Subject: Consequential revisions to the VHF data exchange system (VDES) recommendation

Document 5B/-E

Preliminary Draft Revision of Recommendation ITU-R M.2092-0

Technical characteristics for a VHF data exchange system in the VHF maritime mobile band

Figure 1 - VDES functions illustrated

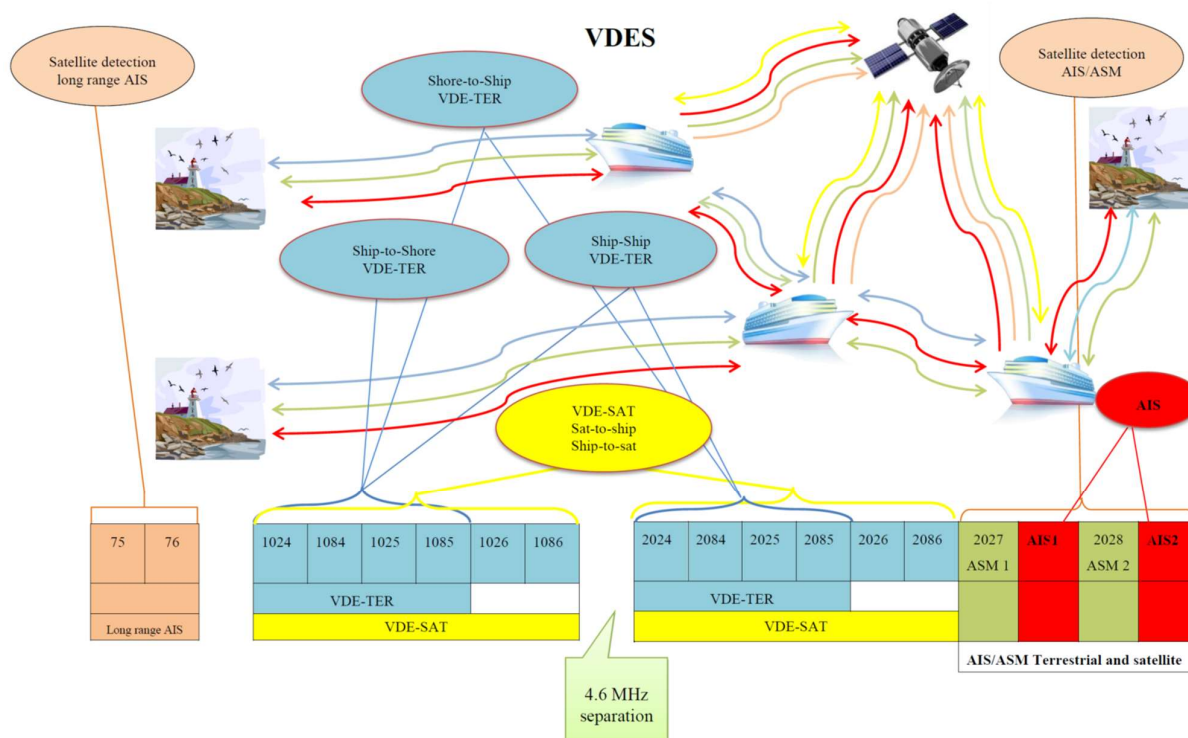
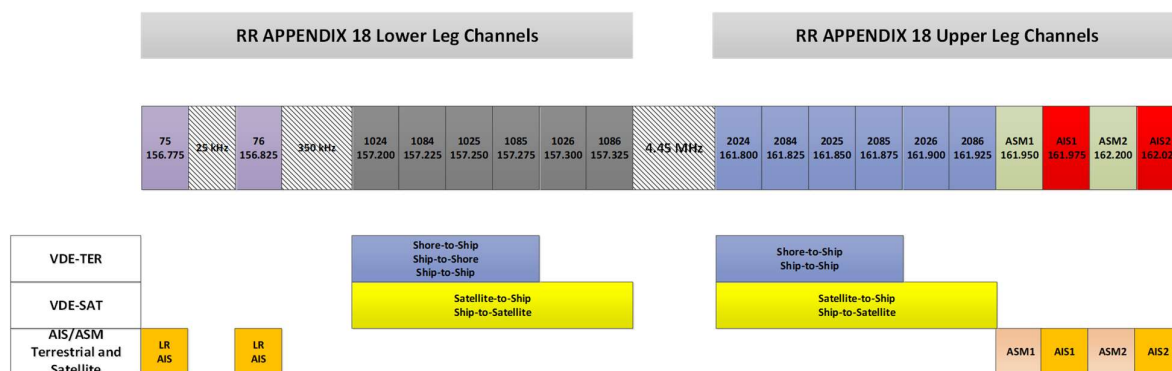
The VDES provides a variety of means for the exchange of data between maritime stations, ship-to-ship, shore-to-ship, ship-to shore, ship-to-satellite and satellite-to-ship. The VDES is a multi-component system comprised of both the VDE-TER and VDE-SAT components, application specific messages (ASM), and the automatic identification system (AIS) in the VHF maritime mobile band (156.025-162.025 MHz). The VDES functions are illustrated pictorially in Figure 1.
